**TECHNICAL INFORMATION**

- Subject** ▶ Change on Field Fixing Screw From Pan Head Screw To Tapping Screw.
- For Models** ▶ 2414B, LC1200, LC1210
- Description** ▶ All Destination, Except U.S.A and Canada.

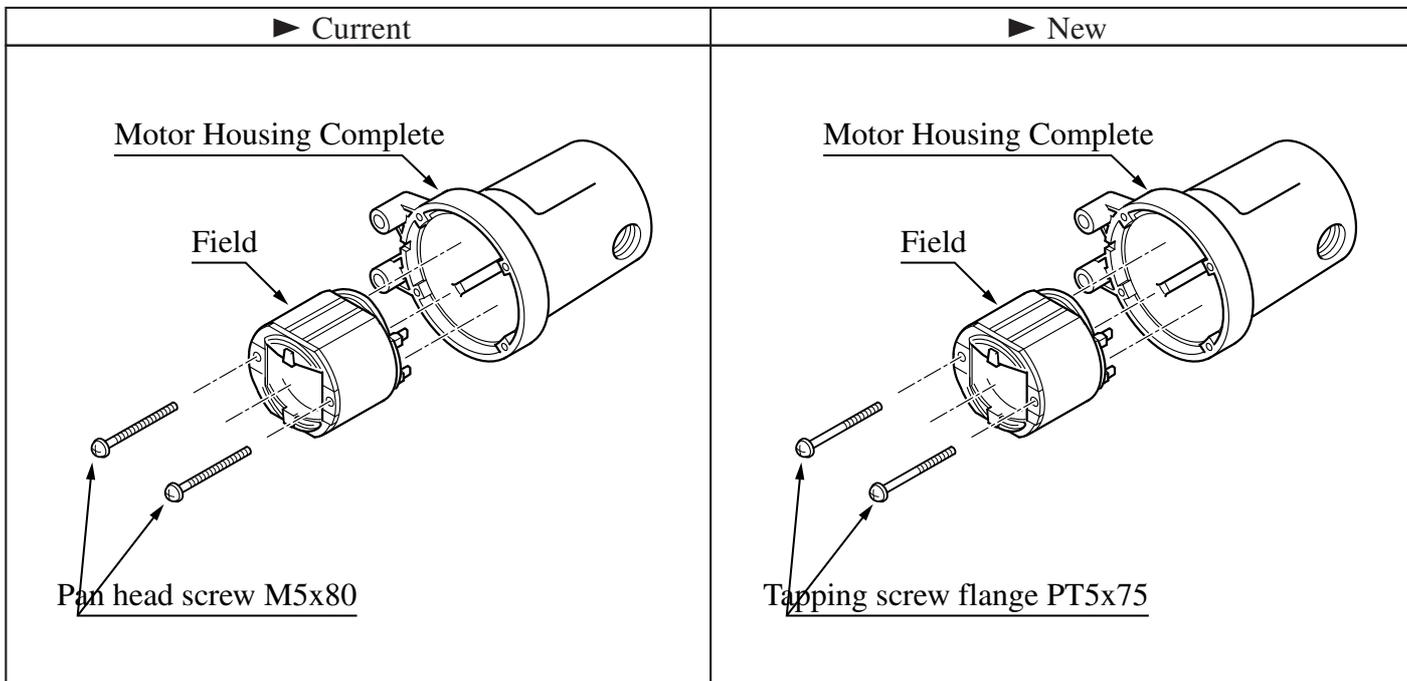
Item No.	Current part	Q'ty	I/C	New part	Q'ty	Note
46	Motor Housing Complete 159673-7	1	No	Motor Housing Complete 159750-5	1	2414B Interchangeable as a Set(*)
80	Motor Housing Complete 159697-3	1	No	Motor Housing Complete 150948-7	1	Lc1200 Interchangeable as a Set(*)
80	Motor Housing Complete 159987-4	1	No	Motor Housing Complete 150949-5	1	LC1210 Interchangeable as a Set(*)
80	Motor Housing Complete 159837-3	1	No	Motor Housing Complete 150950-0	1	LC1200(South Africa only) Interchangeable as a Set(*)
75	Pan Head Screw M5x80 911944-8	2	No	Tapping Screw Flange PT5x75 266059-9	2	*

2414B : From Serial No. 133708E(from  
 LC120 : Feb.1998)  
 0 : From Feb.1998
